Docket Item #12  
DEVELOPMENT SPECIAL USE PERMIT #2003-0016  
DUNCAN LIBRARY EXPANSION

Planning Commission Meeting  
September 4, 2003

**ISSUE:** Consideration of a request for a development special use permit, with site plan, and modifications, and a parking reduction, to expand the existing James M. Duncan Library.

**LOCATION:** 2501 Commonwealth Avenue

*Proposed By Staff:*

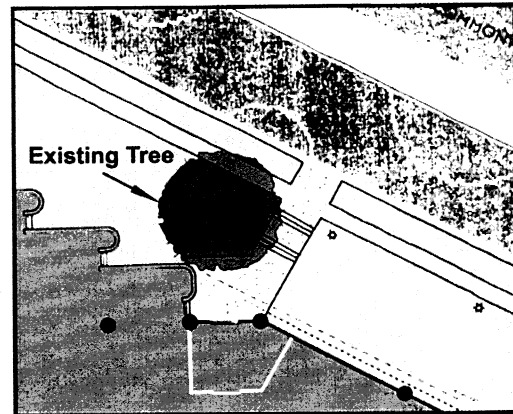
An important component of integrating the proposed addition into this mature, primarily residential neighborhood and to retain the quality of the open space is to retain the many large trees on the site. While initially, it was proposed that several of the existing trees would be removed, the plan, plaza and entrance have been revised on the current plan to retain all but one of the existing trees. The retention of the large tree (14" caliper) on Commonwealth Avenue requires some modification of the size and shape of the front sidewalk entrance to retain the tree as depicted below. The revised entrance will have minimal impact on the functionality of the entrance, the entrance will continue to be visually prominent, provide for a library sign while also retaining the large street tree. Several of the existing trees around the proposed plaza will need to be relocated, which given the size of the trees (approximately 6" caliper), the city arborist believes can be safely transplanted.

- f. Provide crown coverage breakdown which denotes street trees under a separate tabulation.
  - g. A reduction in the sidewalk width at the street entrance to the plaza/school in order to retain the existing 22" Sophora.

FIGURE 3

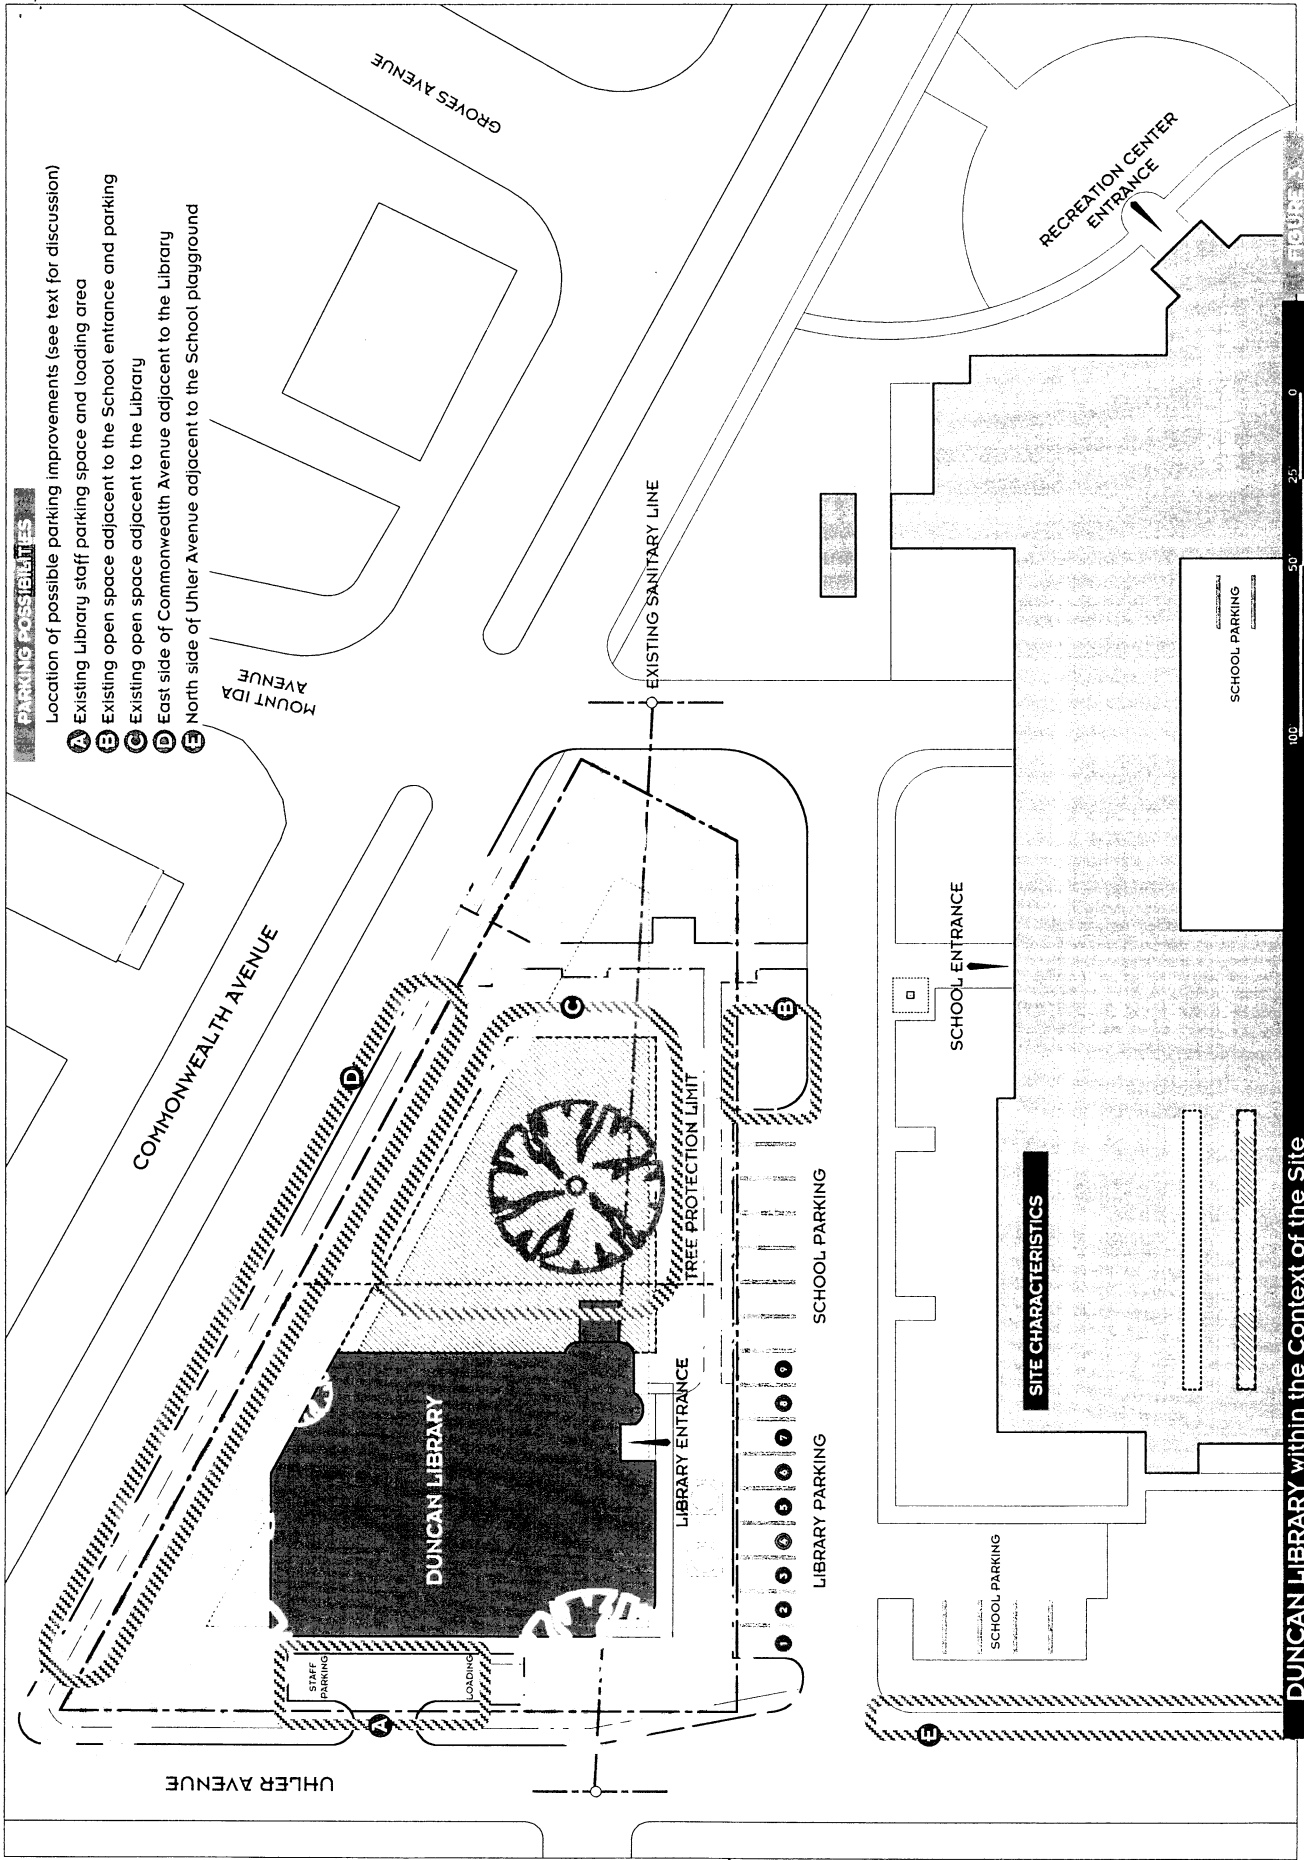
- Location of possible parking improvements (see text for discussion)
- A** Existing Library staff parking space and loading area
- B** Existing open space adjacent to the School entrance and parking
- C** Existing open space adjacent to the Library
- D** East side of Commonwealth Avenue adjacent to the Library
- E** North side of Uhler Avenue adjacent to the School playground

Proposed Bio-Retention Area

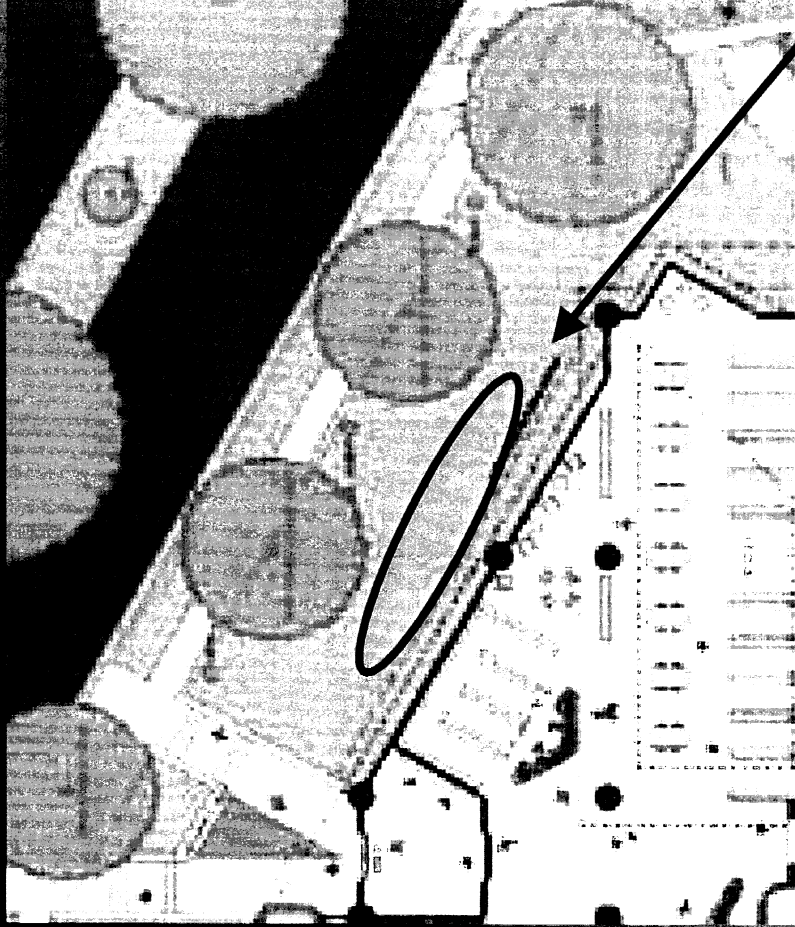
To function properly, a bio-retention area is unsuitable as active open space or planting areas. Although uncharacteristic in the neighborhood, it is required by law and will be a grassy open area.

6. The following revisions at a minimum shall be made to the bio-retention area adjacent to Commonwealth Avenue to the satisfaction of the Directors of Planning and Zoning, Recreation, Parks and Cultural Affairs, and Transportation and Environmental Services:

- b. The materials of the bio-retention area shall primarily be turf, decorative plantings and decorative trees. P&Z)
